BMROSS

7. GSP Concept Update

That BMROSS work with GSP to provide a revised enhanced design and cost estimate that considers, as much as possible, future operational and capital costs through refinements to sidewalk space, tree and landscape areas, and concrete planter quantities, for the Rebuilding Downtown Infrastructure Project;

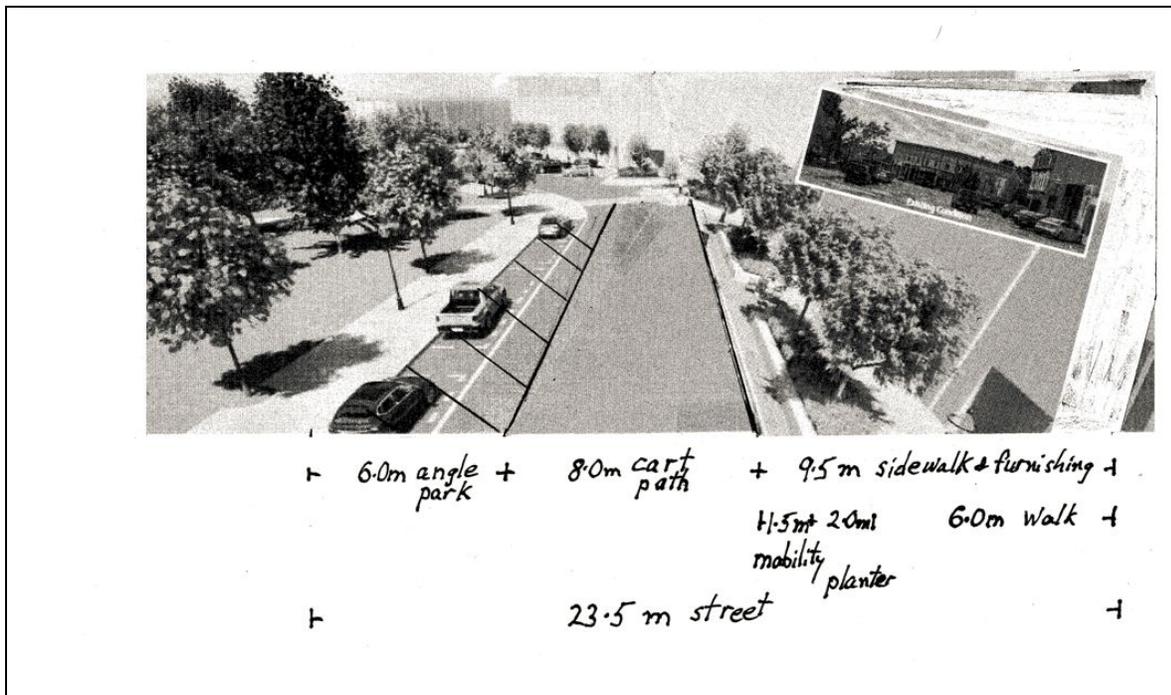
The statement that *"Intersections are designed to provide refuge, meet*

AODA requirements" supports the pedestrian focused design but **falls short** of taking into account the **mobility needs** of many citizens. (See Appendix 1)

Alternate Proposed Streetscape- Con Melady

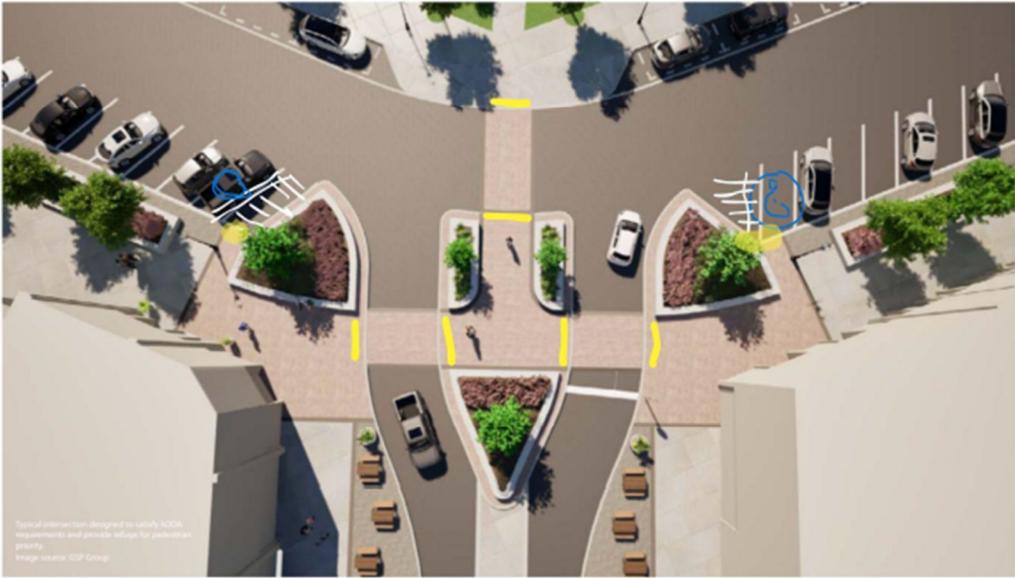
The following images are from the report: image one is an overhead view of the intersection “concept”; image two shows rudimentary markings that I have added to show how accessibility as a concept would be represented. In blue and white ink, accessible parking is shown at each side of the intersection, and tactile warning indicator surfaces are shown in yellow ink.

This second set of images shows the public eating area concept (1) and (2) the same, but with disability and accessibility represented. Yellow ink is used to show tactile warning indicator surfaces at the crosswalks and I’ve added an

image of a person using a wheelchair seated at a picnic table with an extension on the end that makes it accessible.
